***REPLACEMENT PAGES FOR APPENDIX A
CRYSTAL RIVER UNIT 3
TECHNICAL SPECIFICATIONS***

3.7.15 Spent Fuel Assembly Storage

Figure 3.7.15-1 (page 1 of 3)
Burnup versus Enrichment Curve for
Spent Fuel Storage Pool A

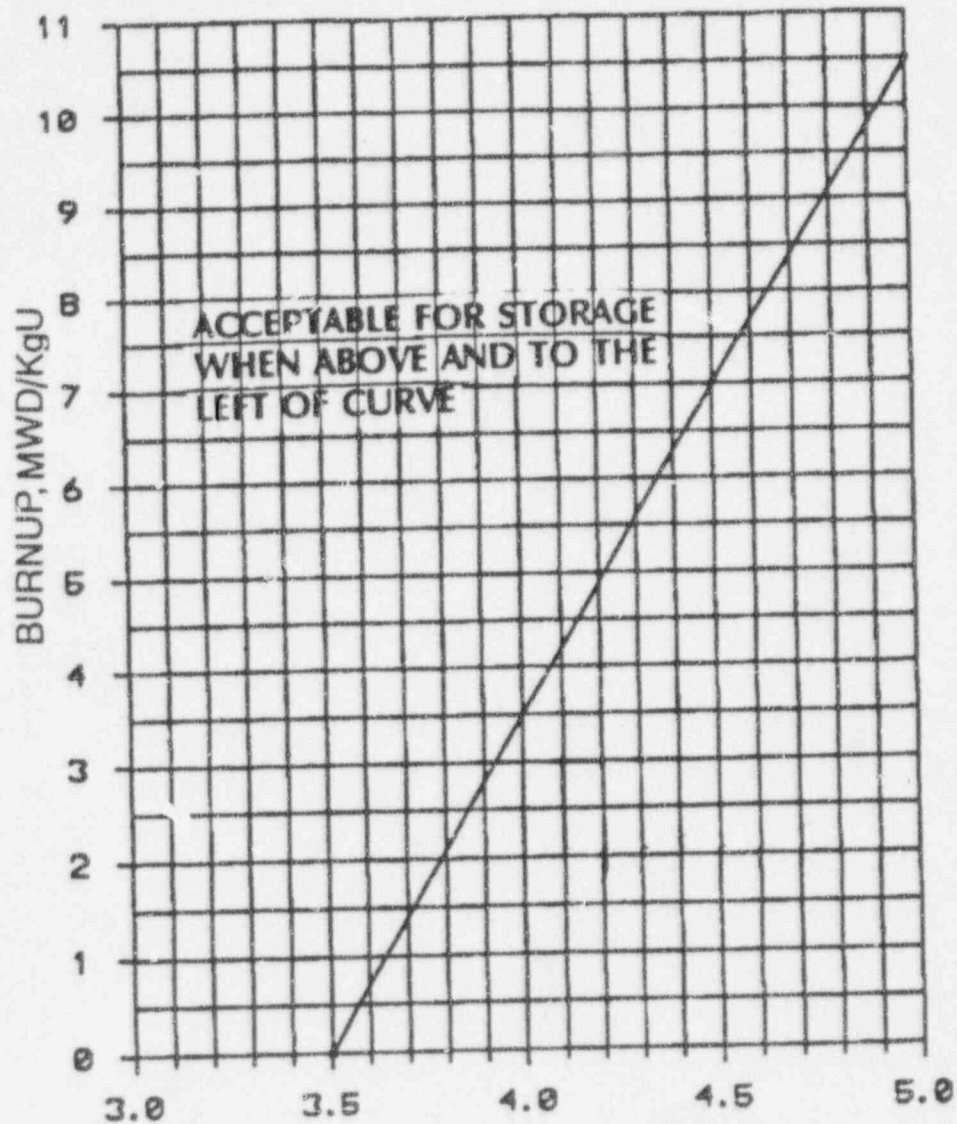
LCO 3.7.15 The combination of initial enrichment and burnup of each spent fuel assembly stored in Storage Pool A and Storage Pool B shall be within the acceptable region of Figure 3.7.15-1, Figure 3.7.15-2, Figure 3.7.15-3, or stored in accordance with the FSAR.

2. For spent fuel with initial enrichment less than or equal to 5.0 weight percent and greater than or equal to 3.5 weight percent, fuel burnup must be within the limits specified in Figure 3.7.15-1. (Figure 3.7.15-1 presents required fuel assembly burnup as a function of initial enrichment.)

Figure 3.7.15-2 (page 2 of 3)
Burnup versus Enrichment Curve for
Spent Fuel Storage Pool B, Region 1

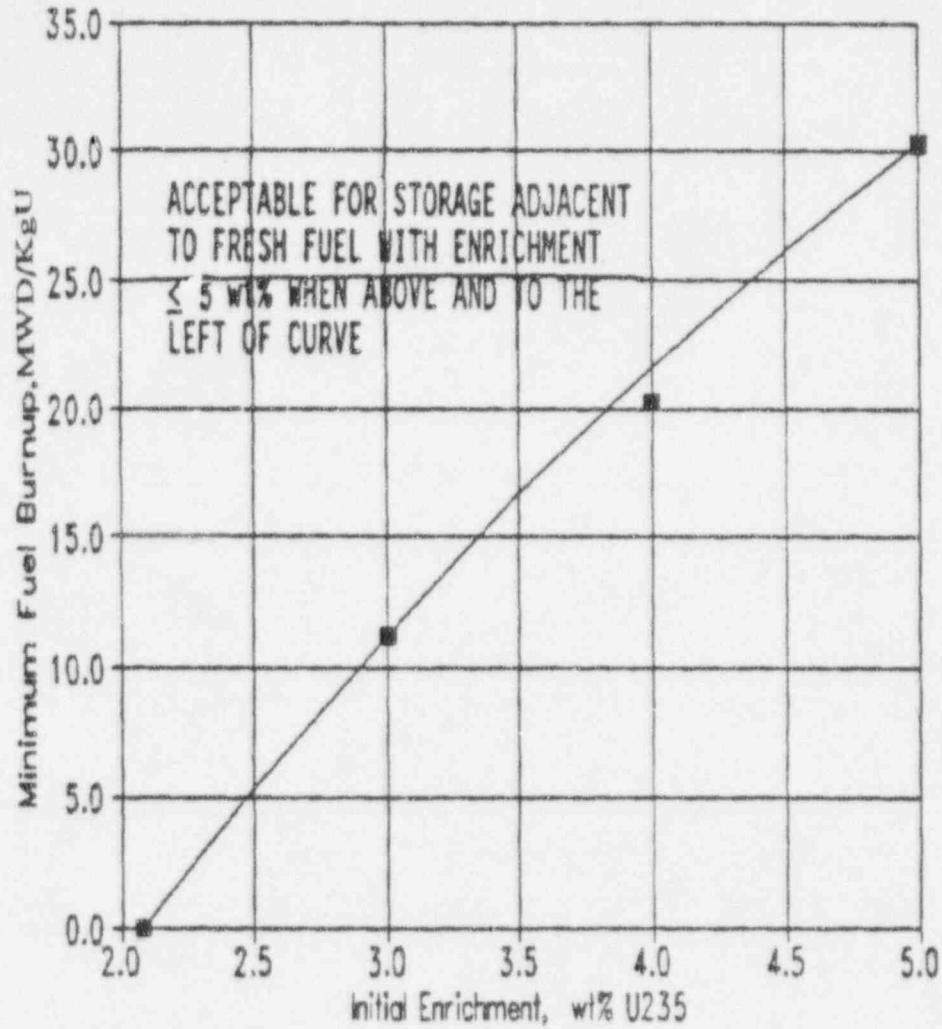
1. Initial fuel enrichment must be ≤ 5.0 weight percent U-235,
2. For Region 1, fuel with initial enrichment ≤ 5.0 weight percent and ≥ 2.08 weight percent fuel burnup must be within the limits specified in Figure 3.7.15-2 and arranged in a required checkerboard configuration with new fuel or burned fuel of ≤ 5.0 weight percent, and
3. For spent fuel with initial enrichment ≤ 5.0 weight percent and ≥ 1.63 weight percent in Region 2, fuel burnup must be within the limits specified in Figure 3.7.15-3. (Figure 3.7.15-3 presents required fuel assembly burnup as a function of initial enrichment.)
